Addendum 01

Project: CSV Lansdowne Auditorium Renovation **Date:** 06 December 2024
330 Lansdowne Ave, **Pages incl. cover:** 21
Toronto ON

The following changes, additions, deletions and clarifications are hereby made an integral part of the documents, including the drawings and specifications for the above project.

841U U3A0

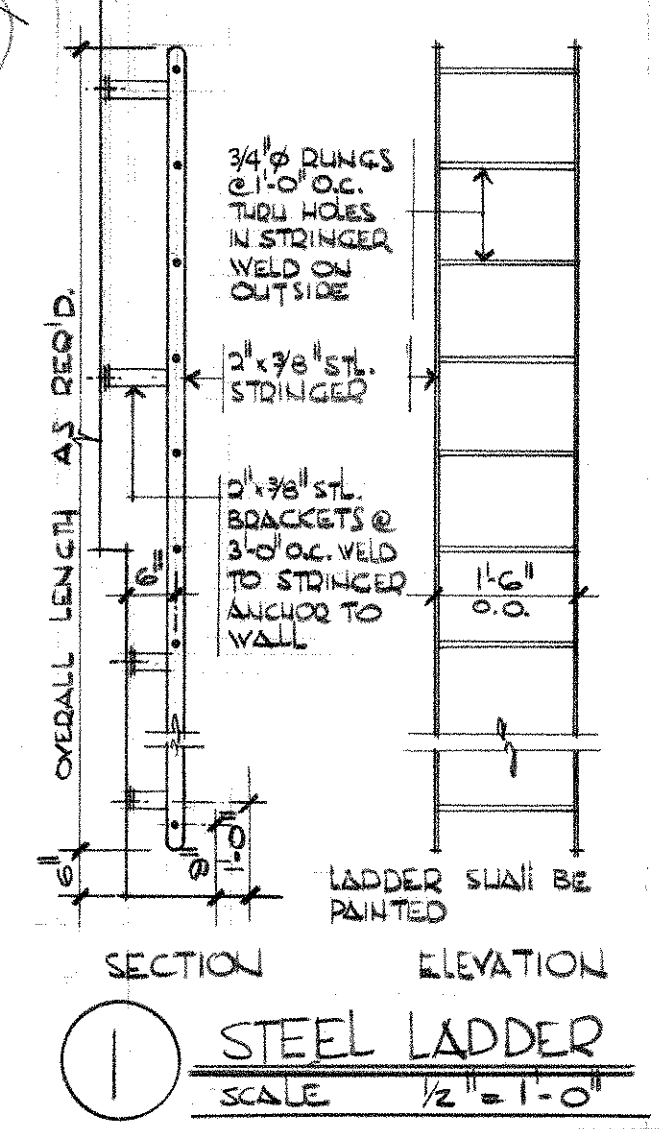
Item	Description
1.01	Clarification: Electrical Legend & Details Refer to Electrical Addendum E-1 (2 pages)
1.02	Clarification: Pre-qualified Abatement Remediation Contactors Refer to Appendix B2 - Subcontractors for updated list
1.03	Clarification: Access to ceiling space above auditorium Refer to record drawing A-1 of catwalk in accessible ceiling above the auditorium. Refer to photos below of existing condition, taken from outside the Level 3 electrical room access hatch. Drawings and photos are provided for information only and It is the contractor's responsibility to verify their accuracy. 
1.04	Clarification: Flooring replacement in Passageway 1-13 Remove and replace RES flooring and RB nosing at existing stair in Passageway 1-13. Refer to room finish schedule on drawing A0.1 and A3/A1.0.
1.05	Addition: Carpet replacement at main auditorium projector podium walls.

3 Level 01 - Proposed
3/32" = 1'-0"

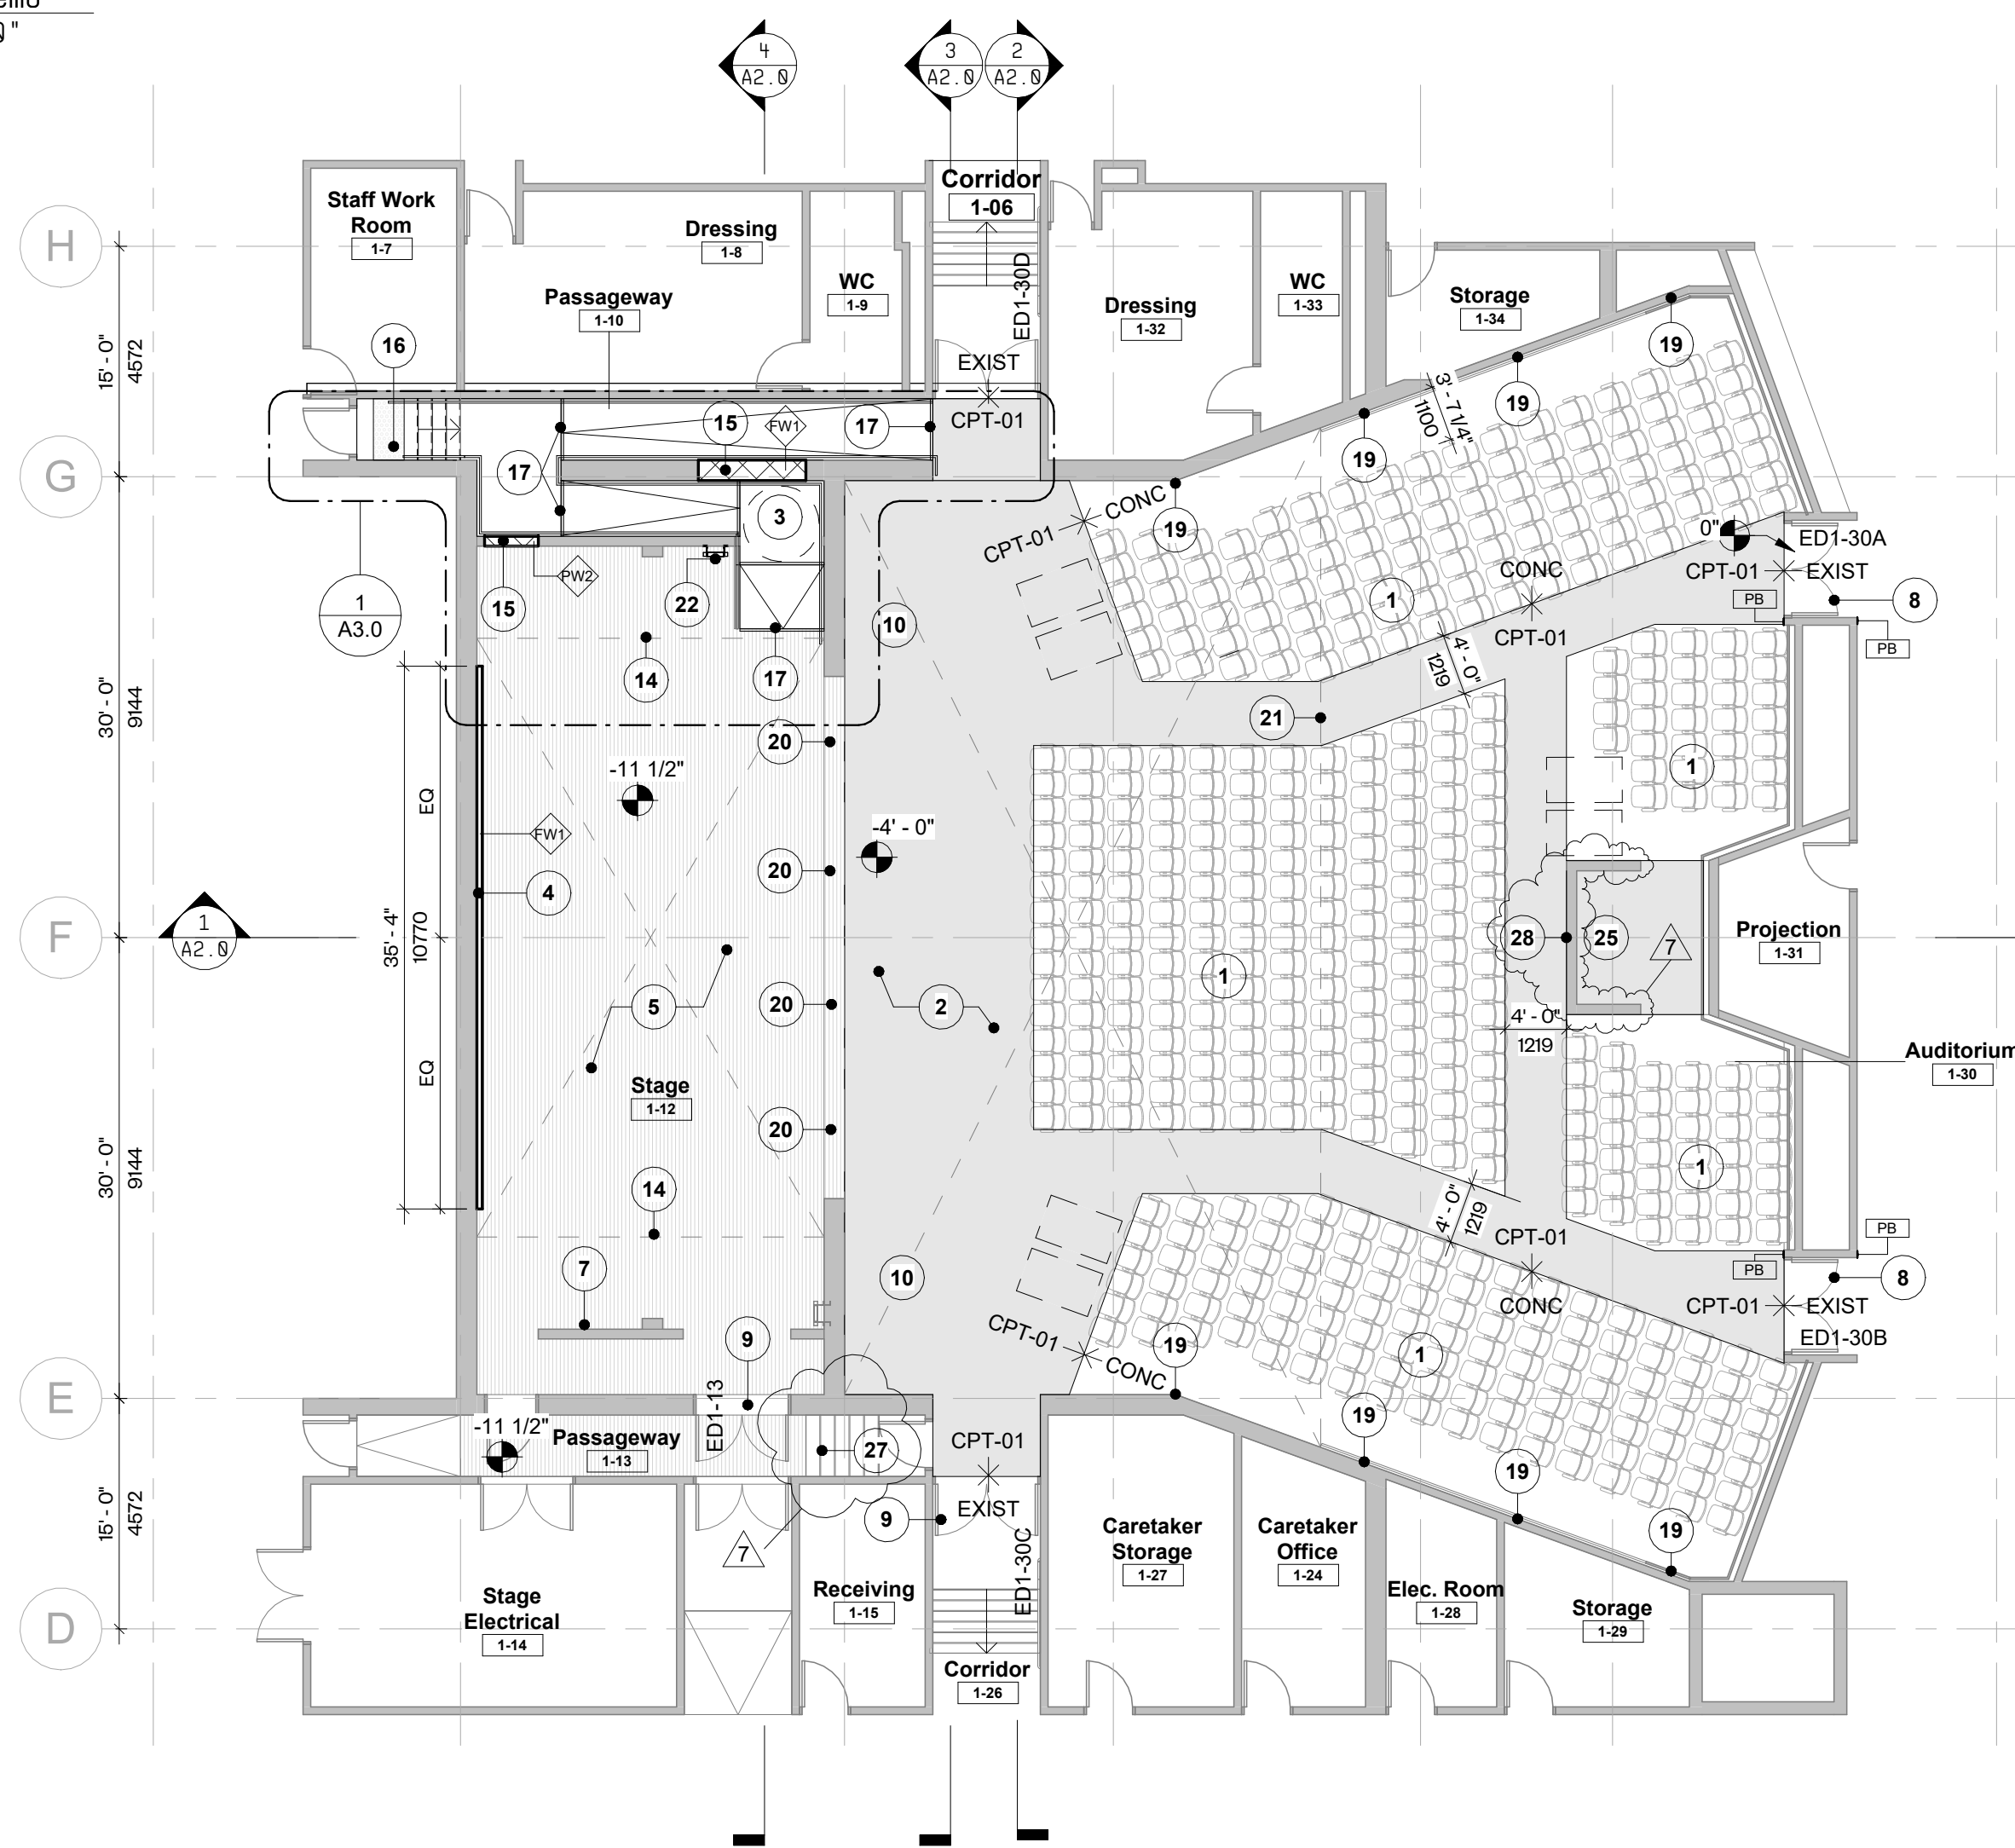
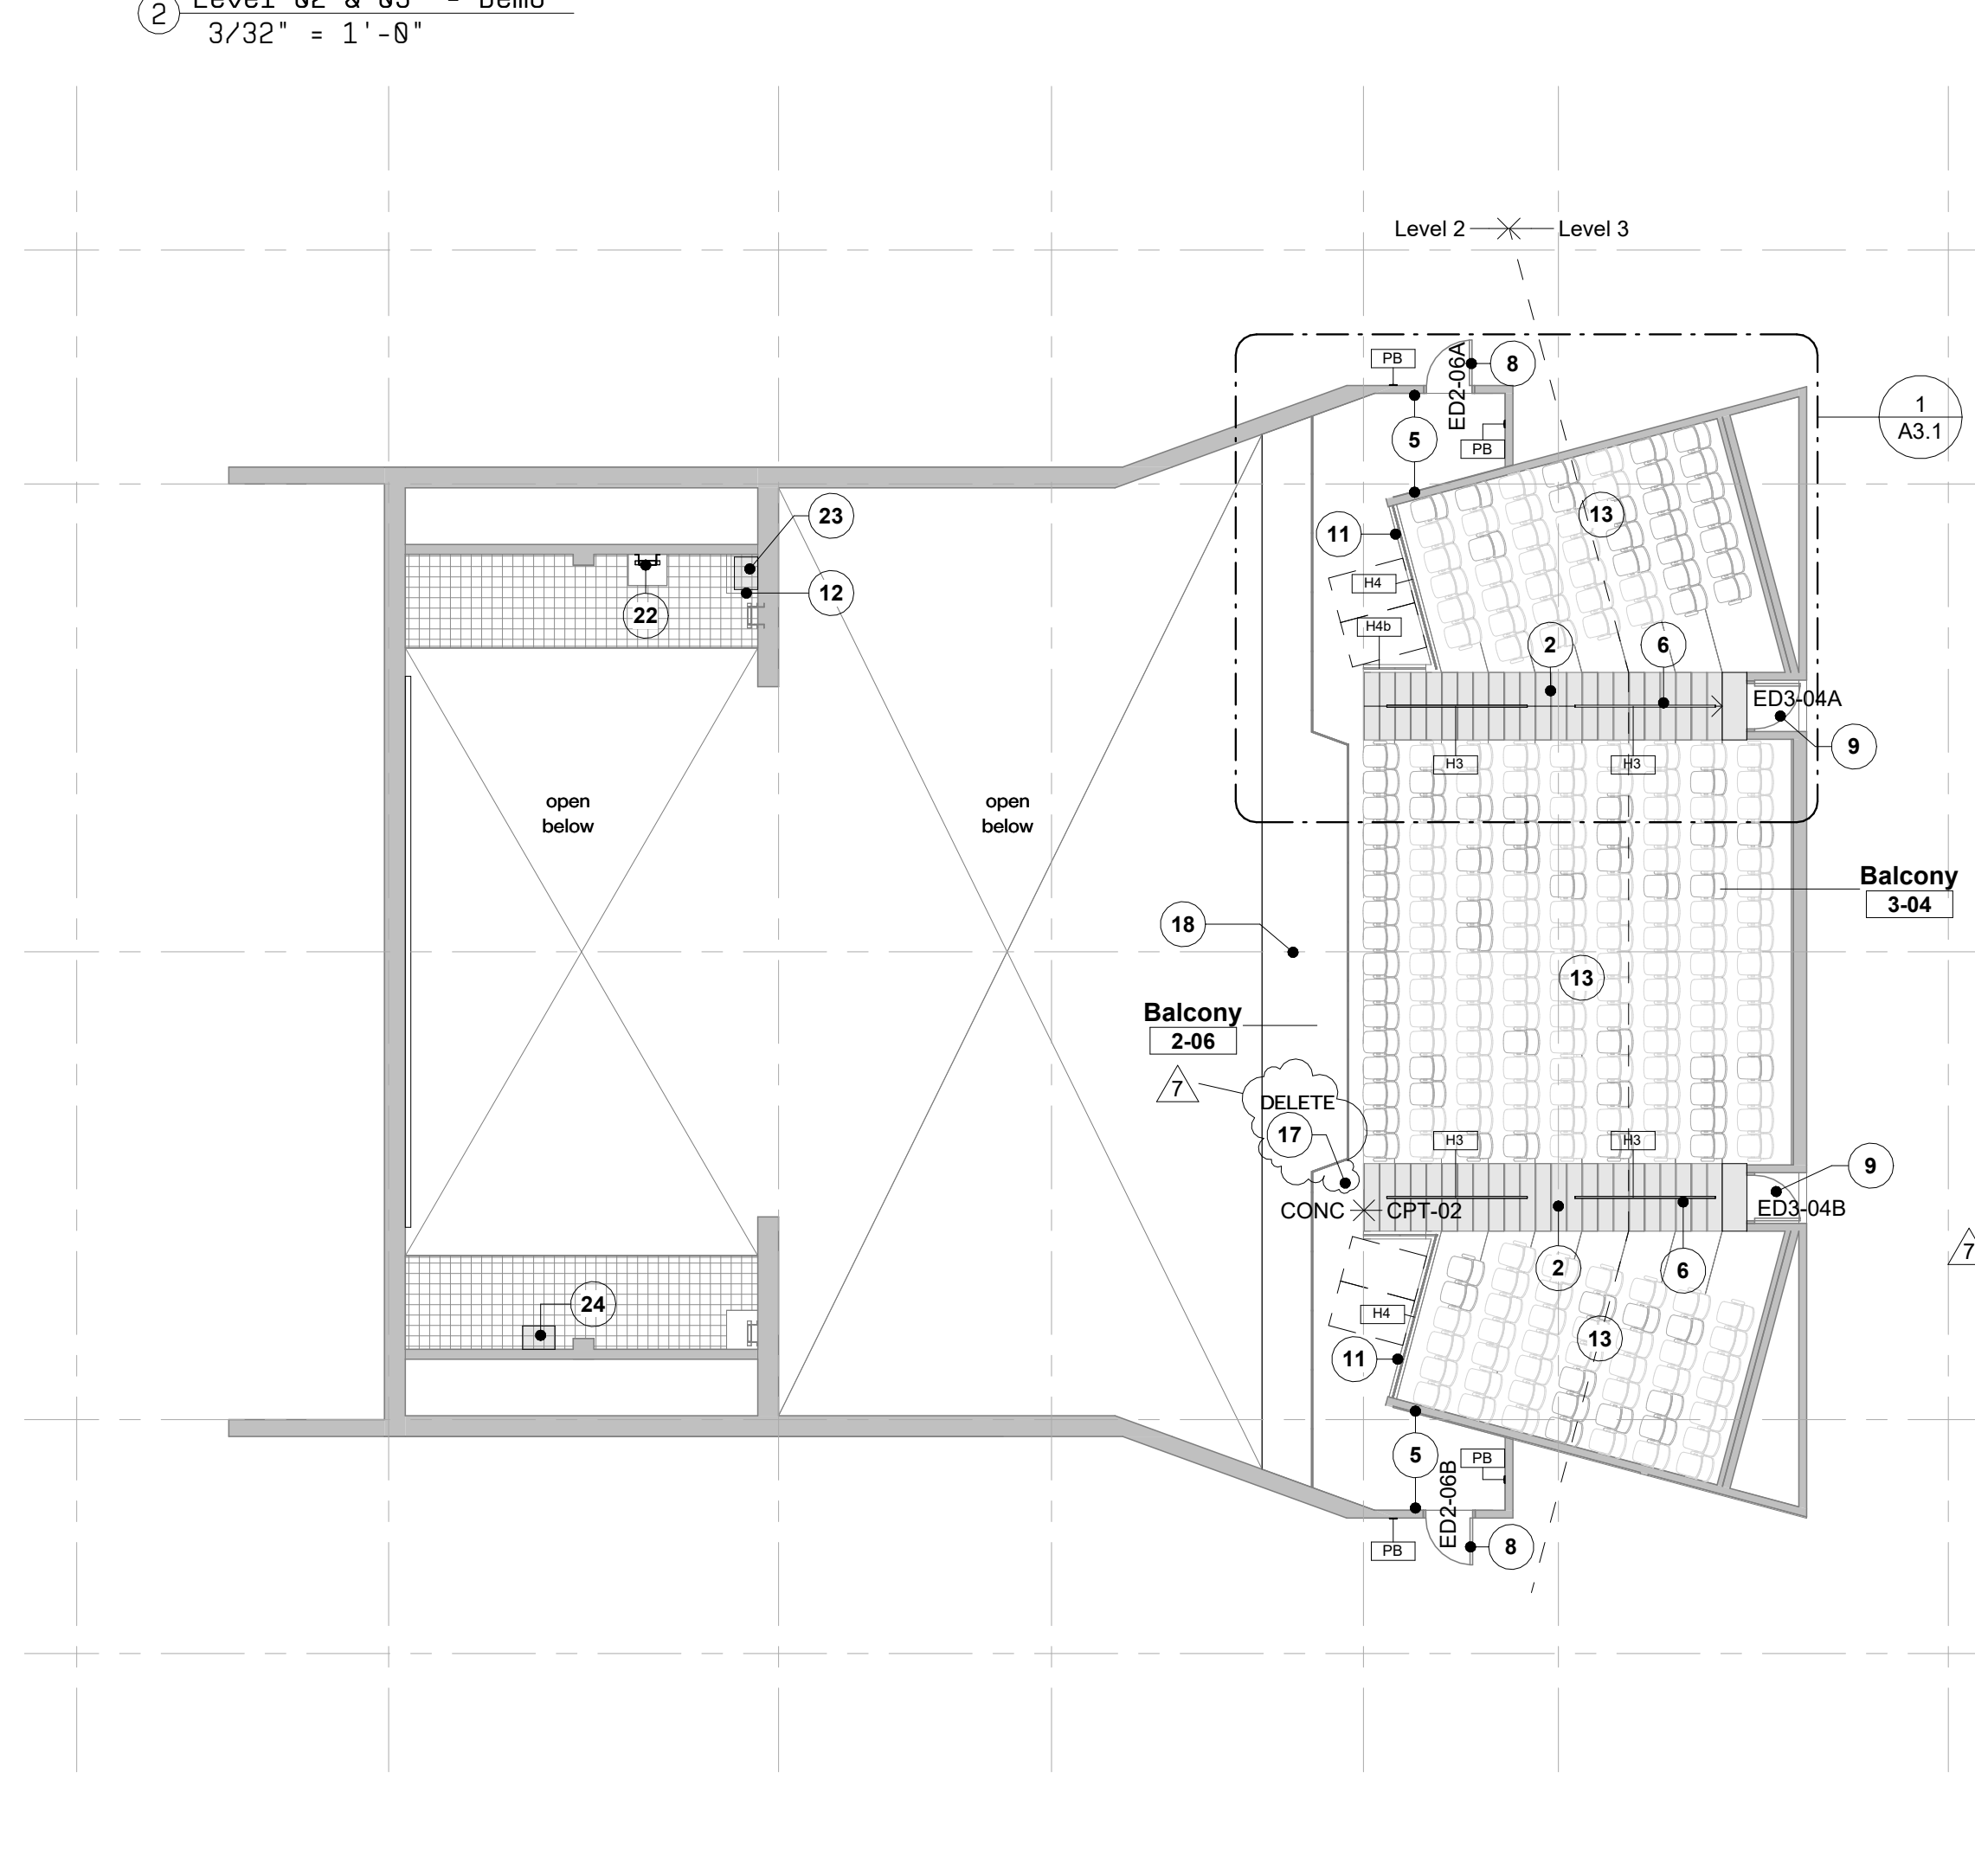
1.06	<p>Deletion: Balcony 2-06 Stairs Delete contrast strip requirement at bottom of balcony stairs on drawing 4/A1.0.</p>
1.07	<p>Question: A1101 does not indicate a specific location balcony projector as requested for separate price on appendix B3. Is it acceptable for the installation to simply sit on the existing ledge similar to the current application? Answer: Yes, that is acceptable for the balcony projector specifically</p>

1.15	Question: Is the fixed-up stage wall / cyc re-finishing part of this construction scoped if so to what finish grade? Answer: The cyc wall is part of the scope per note 4 on drawing A1.0 and drawing 4/A2.0.
